Notice of Allowability	Application No.	Applicant(s)	
	10/614,914	GLEACHER, JEFFREY D.	
	Examiner	Art Unit	
	Eric Culbreth	3616

EXAMINER'S AMENDMENT

Fig-2

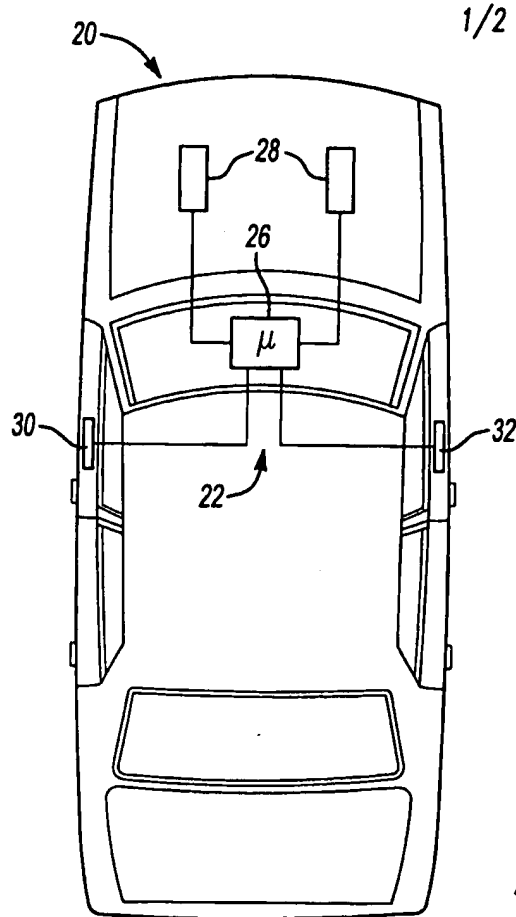
2. The following changes to the drawings have been approved by the examiner: In Figure 2, "DEF" was changed to, --"DIF"--, as it is an abbreviation for "difference" (see the accompanying corrected drawing of Figure 2). In order to avoid abandonment of the application, applicant must make these above agreed upon drawing changes.
